Re: Second Submission Review – CJG Transport Outdoor Storage – Site Plan & Plat

Application Number: **DA-2328-00**

Case Numbers: **2022-6056-00, 2022-3086-00**

Project Name	SEMI TRUCK PARKING
Project Address	2252 TOWER ROAD AURORA, CO 80011
Scale	
SCALE - 1:50	
Description	LANDSCAPE PLAN

L 1.0

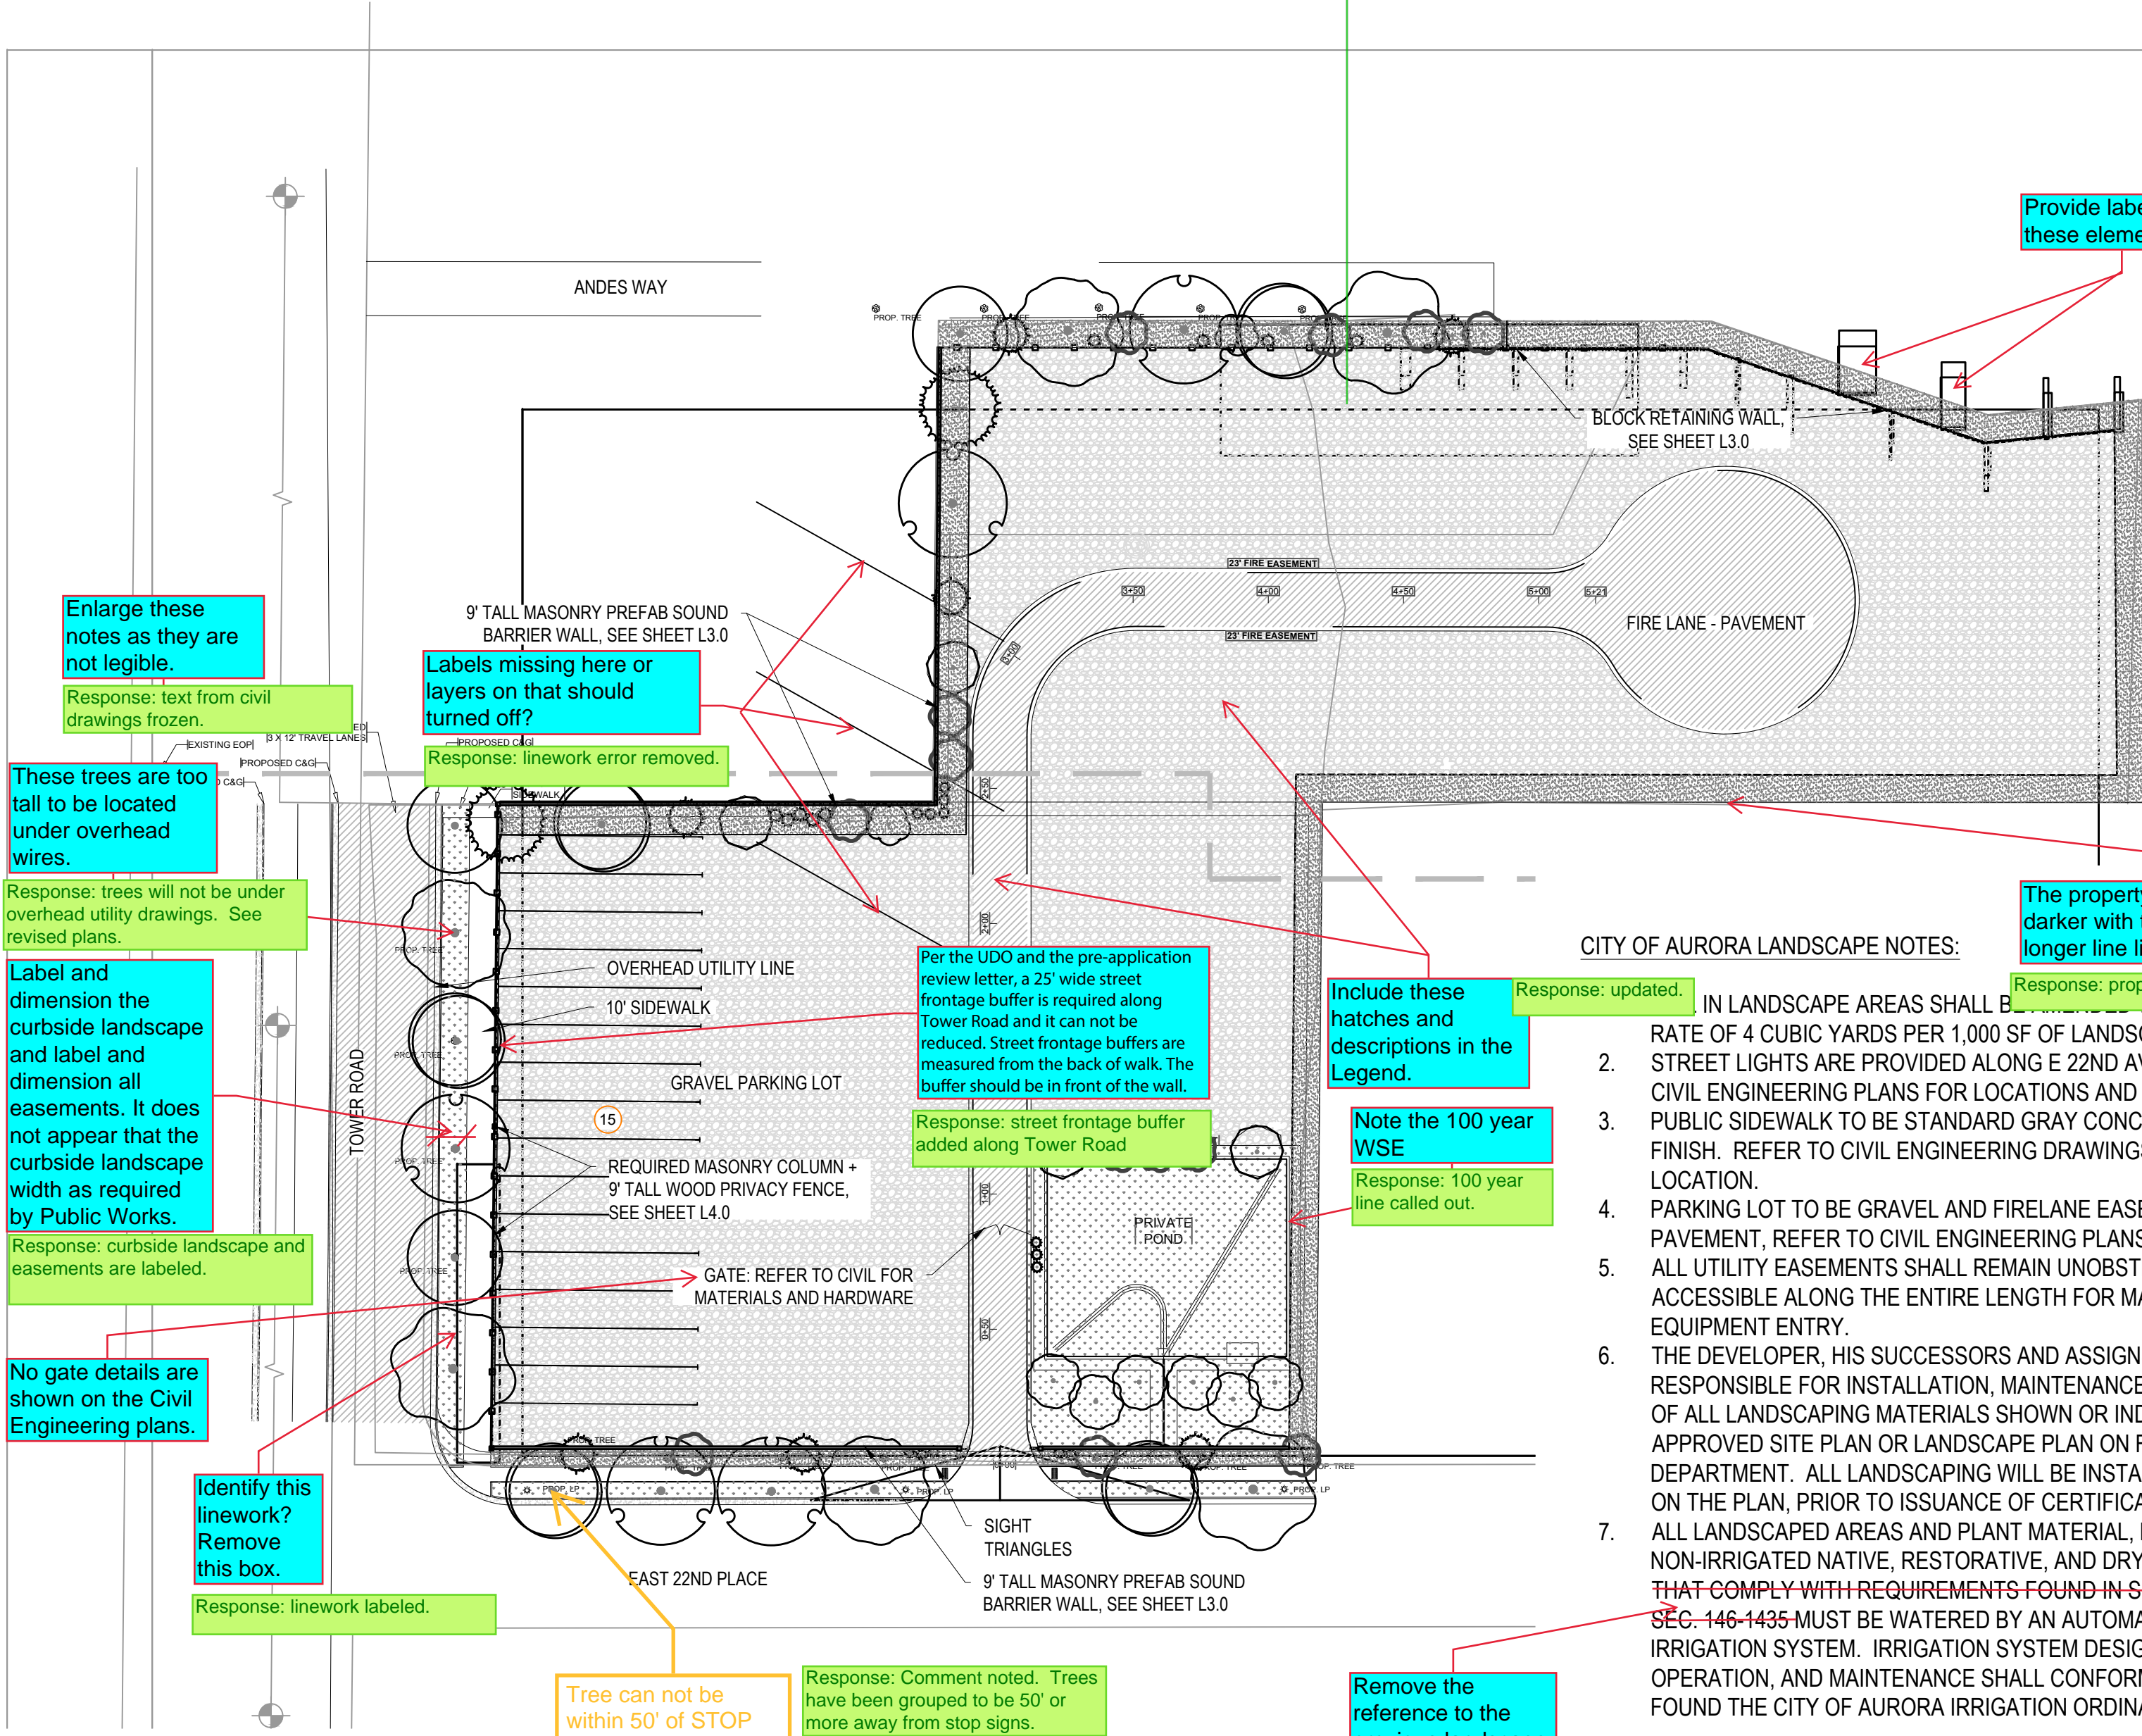
Where is Tower Road? 25' required, Can not be reduced. See additional comment this sheet.

On all sheets remove the Irrigation notes.

Response: notes removed.

SHEET L2.0

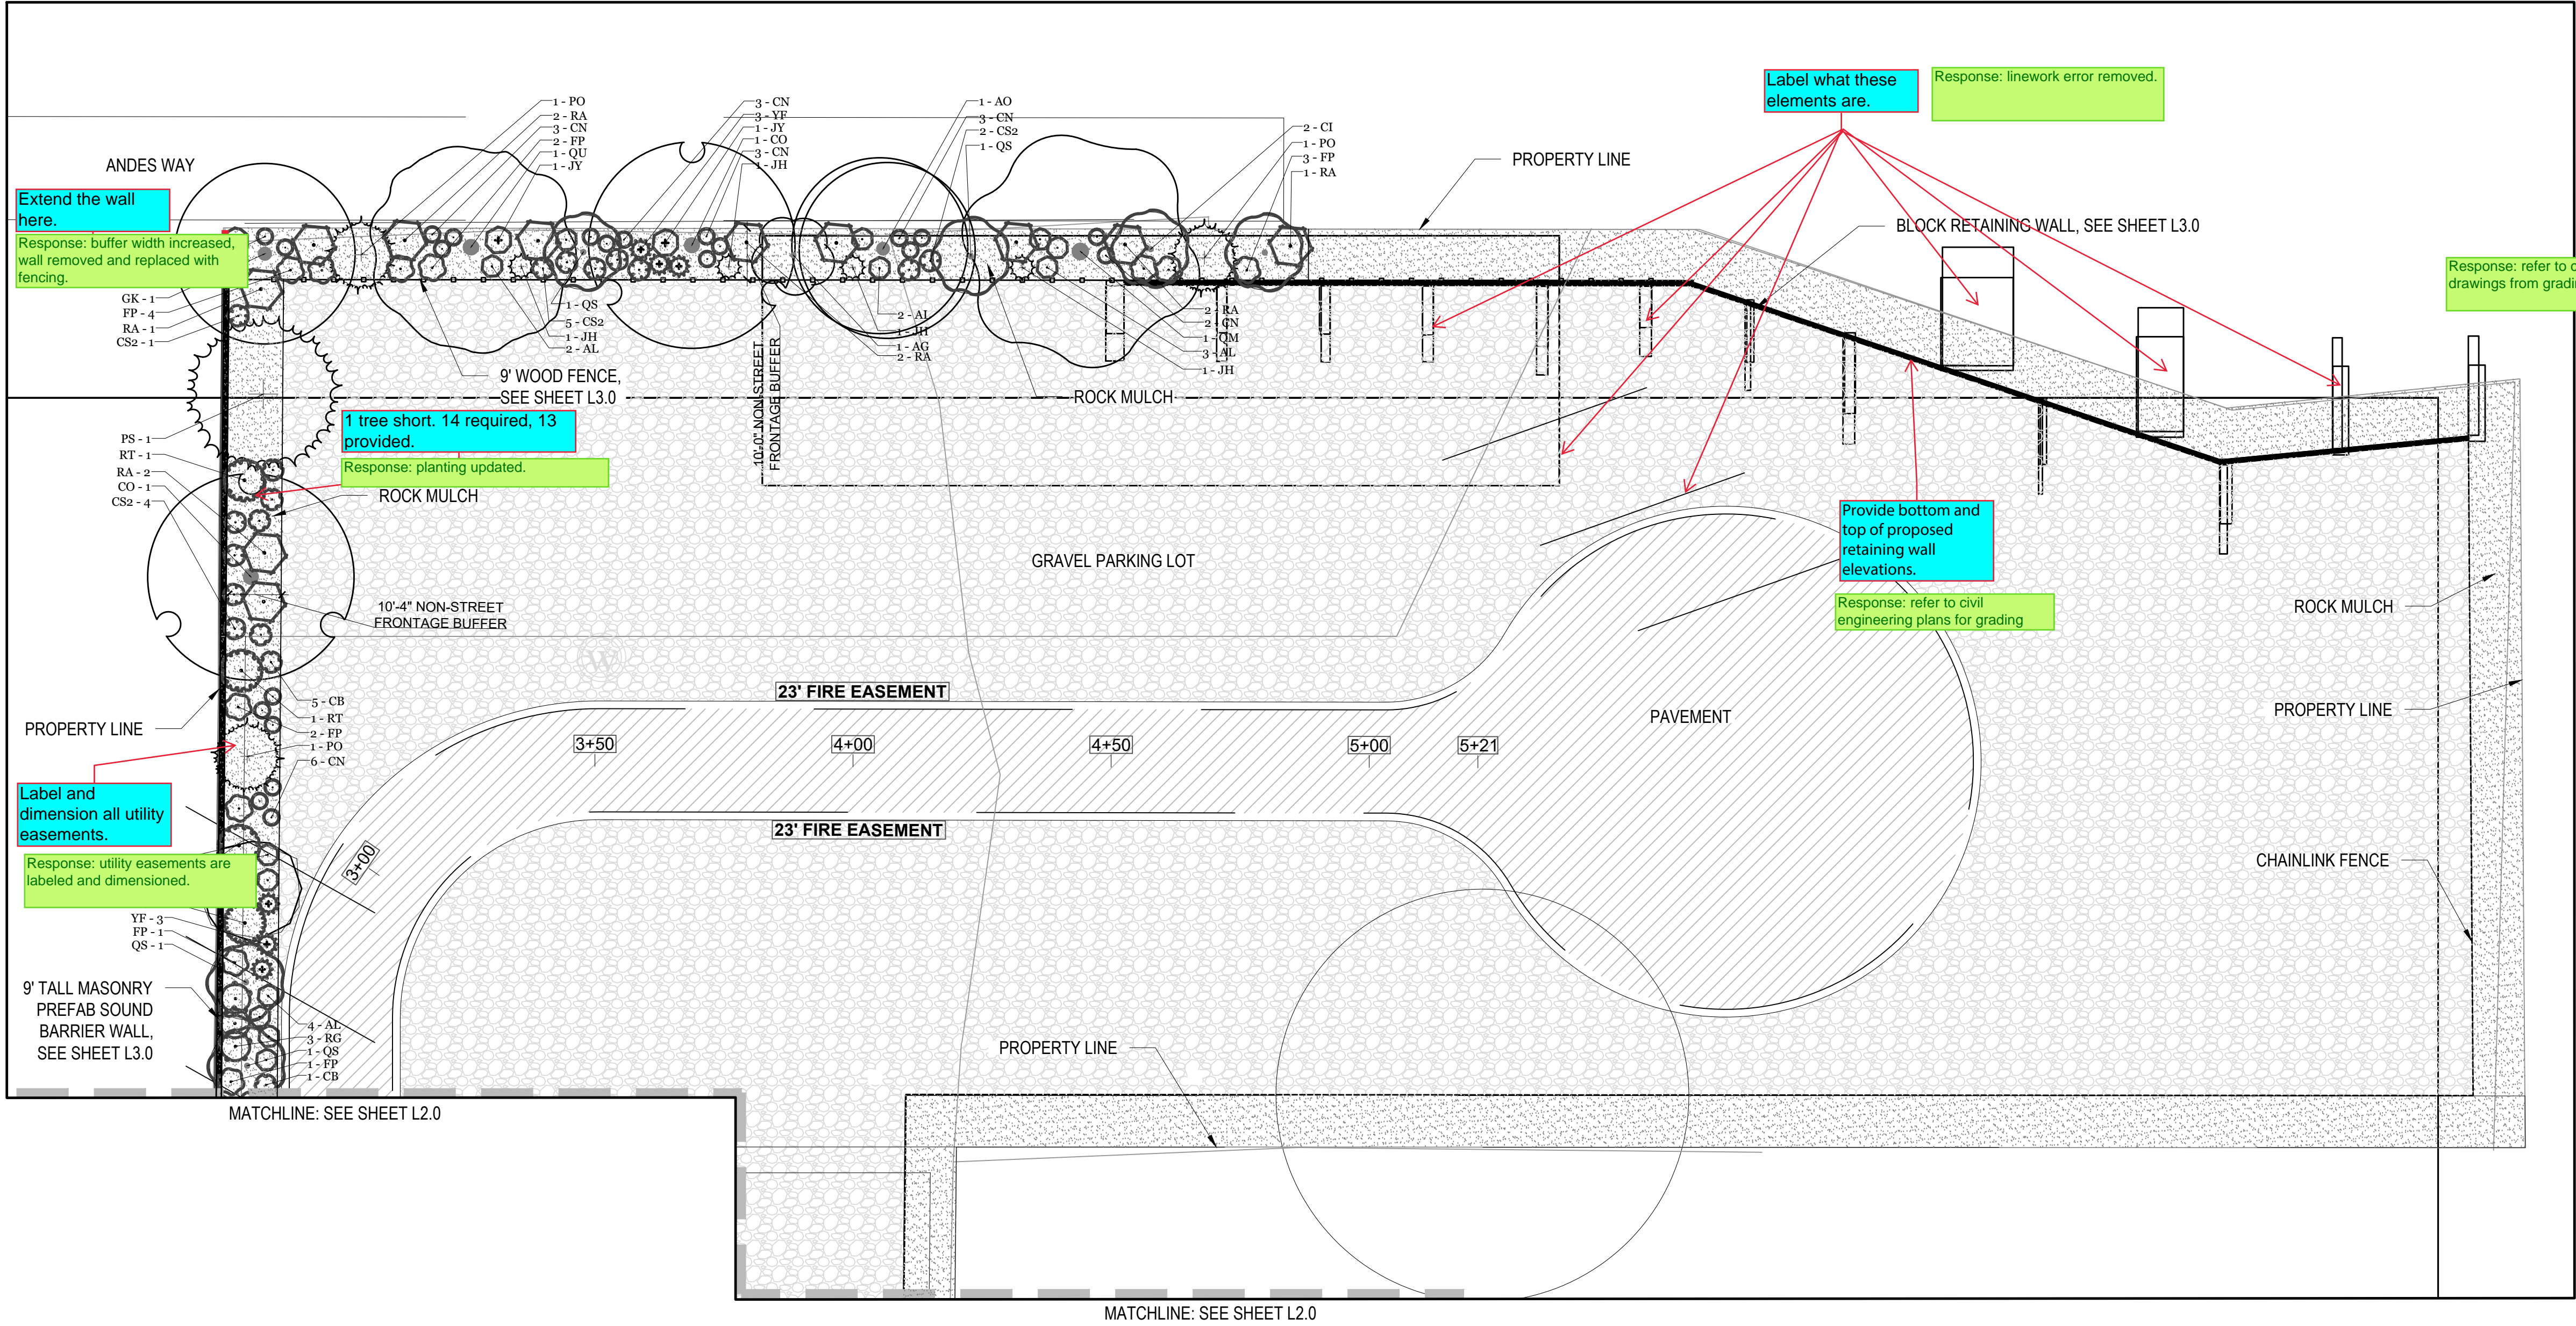
Only include the required landscape notes on one sheet.

Remove Notes

Response: notes removed.

Response: notes removed.

L 3.0

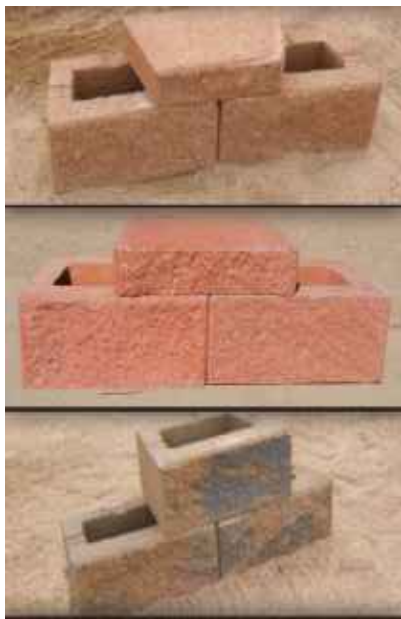
Provide a gate section. Ensure the gate section/detail uses the naming convention identified on the site sheet.

The Masonry Wall detail is missing or did not print properly, please add this in for the next review. A detail of the masonry column is also missing and should be provided here.

Provide the max height or height range for the proposed retaining wall.

Any retaining walls over 30" require railing. Any CIP walls and any walls over 4' require structural calculations.

Provide the detail for the 9' tall masonry prefab sound barrier wall.

Response: refer to civil engineering plans for vehicular gate information.

Response: Detail Provided

Response: refer to civil engineering plans for grading info.

Response: Detail Provided
